Responses to queries raised by the DAC regarding faculty reports submitted by Holy Trinity Church Hurdfield.

Queries from Katy Purvis (email of 13/01/2020)

Queries from the reviewing architect (email of 20/01/20)

The section of the topo survey below shows the location of the 3 trees.

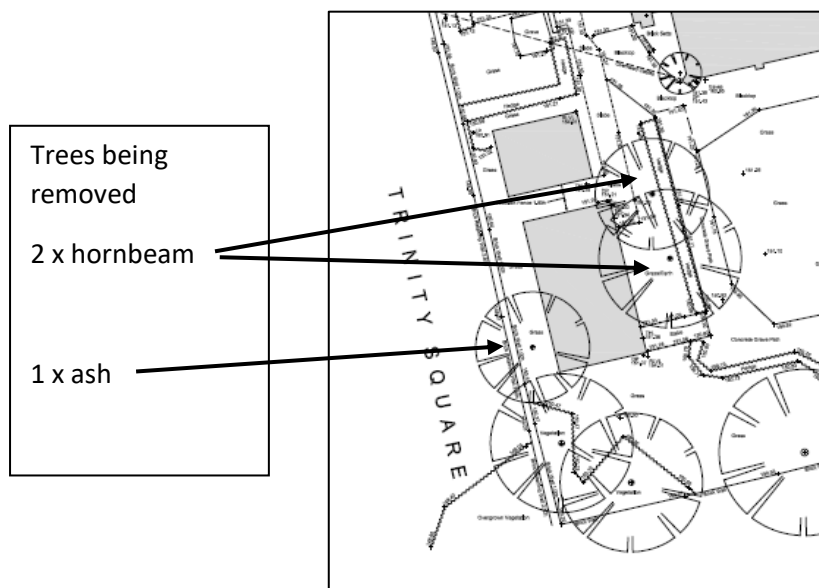
- I have not seen a plan clearly identifying which trees are to be removed. The topographical survey in bundle A shows the existing layout, suggesting two or three trees may be ‘a problem’ – further information and reasoning please.

The trees that will be removed, as agreed with Archdeacon Ian, are the 2 trees immediately in front of the current classroom portacabin (in front of the east wall of the portacabin) and a single ash tree that is located at the rear of the current building on the southwest corner.

They all need to be removed as they already encroach on the existing building and as we put the new building in, they will do the same. The Ash tree is in very poor condition, covered in ivy and stands between the building and the perimeter wall. The hornbeam trees are too large and several of the branches are already drooping over the roof of the existing portacabin. They also block access and light to the front aspect of the new building and so, to allow access to the building from the grassed area need to be removed.
